**Re: Comments of GPA Midstream Association on the U.S. Environmental Protection Agency's Proposed Rule "Waste Emissions Charge for Petroleum and Natural Gas Systems," 89 Fed. Reg. 5318 (Jan. 26, 2024); Docket ID No. EPA–HQ–OAR–2023–0434**

**Comments of GPA Midstream Association on the U.S. Environmental Protection Agency's Proposed Rule "Waste Emissions Charge for Petroleum and Natural Gas Systems"**

**89 Fed. Reg. 5318 (Jan. 26, 2024); Docket ID No. EPA–HQ–OAR–2023–0434**

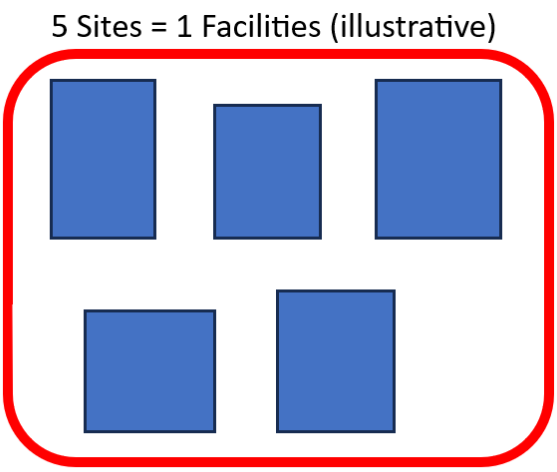
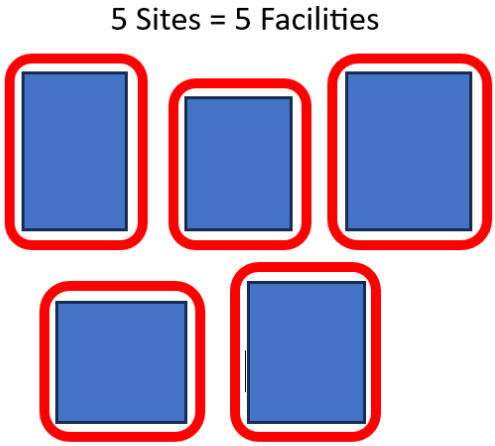
Despite an operator's best efforts, deviations occur. If the regulatory compliance exemption is applied on a basin-wide basis, just one instance of non-compliance among hundreds or thousands of emission sources within an entire basin eliminates the compliance exemption for all the other sources in that basin that are in full compliance. EPA's proposal is therefore likely to render the compliance exemption ineffective for basin-level reporters, subjecting midstream sources to the WEC even when the vast majority of those sources are in compliance with section 111 requirements. In contrast, the impact of losing the compliance exemption due to an instance of non-compliance is limited for other industry segments that report each site separately. Congress could not have intended such a result, and it is possible Congress did not understand the sweeping and nuanced nature of the term "facility" for some Subpart W industry segments. GPA has long opposed the basin-wide approach as ill-suited to the midstream sector, and EPA retains authority to take a different approach.[60] EPA should revise its definitions in both this Proposed Rule and Subpart W to give better effect to the regulatory compliance exemption for the midstream sector.[61]

As an alternative, if EPA is going to retain its position that any deviation can cause a facility to be in noncompliance and to thus lose the regulatory compliance exemption, the Agency should, at the very least, provide regulated facilities with a mechanism by which to petition EPA for a finding that a deviation or violation of the rules is nonmaterial. Under such a mechanism, if a facility could show that a deviation or violation did not result in excess emissions or other environmental harm, the facility would not be deemed in noncompliance and would be allowed to retain its WEC exemption for regulatory compliance.

*Figure 1: Copied from "Figure 3.1.1 Parity plot for Methane K-values for Data from RR-23, 40, and 193" from Mamrosh et al.*

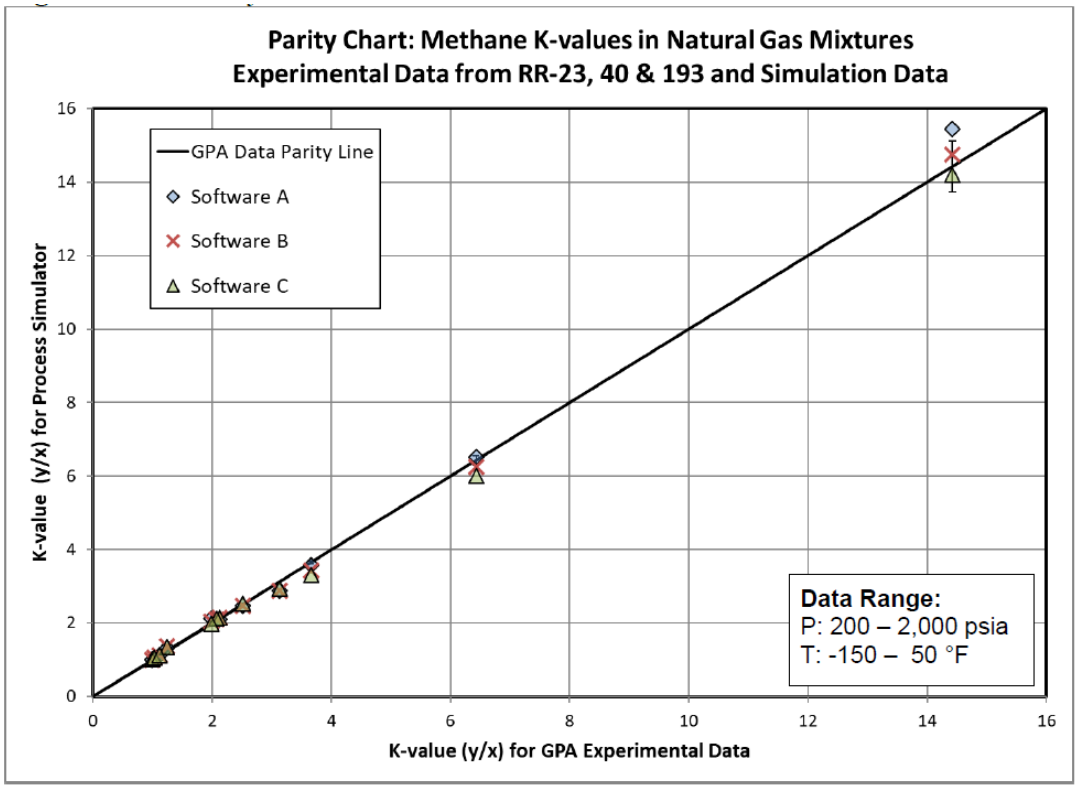
graphed on the x-axis and the simulation value on the y-axis, such that the parity line is the experimental data, and the simulation predictions are the points shown on the graph. In this source, the error bars shown are those of the experimental data. This research report utilizes an equilibrium constant K-value (a representation of solubility) for convenience in comparing Vapor-Liquid Equilibrium data. This shows that process simulators are typically very accurate at predicting methane content from AGRUs.

*Figure 2: Copied from "Fig. 2. Simulator vs. operating data for sweet gas $CO_2$ concentration" in Pieronek et al.*

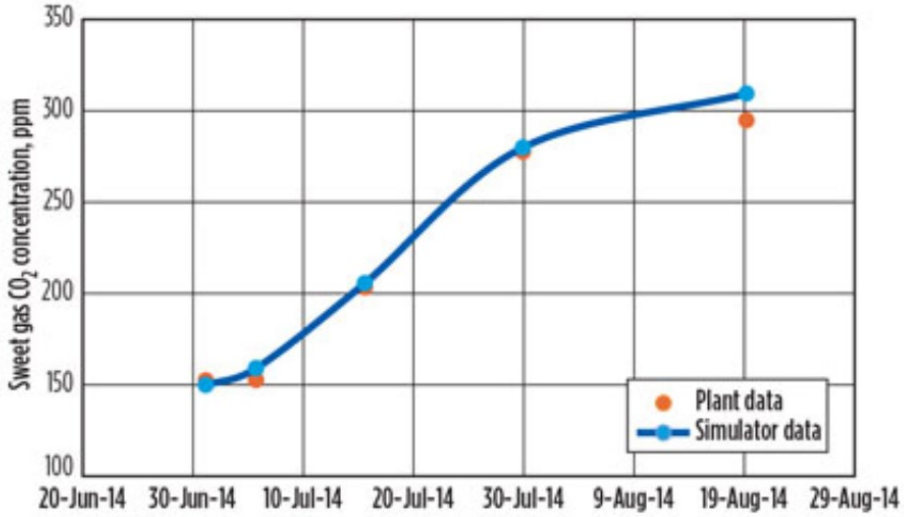
Similarly for $CO_2$ in AGRUs, the figure below from Pieronek et al.[65] shows very good agreement between data and simulation.
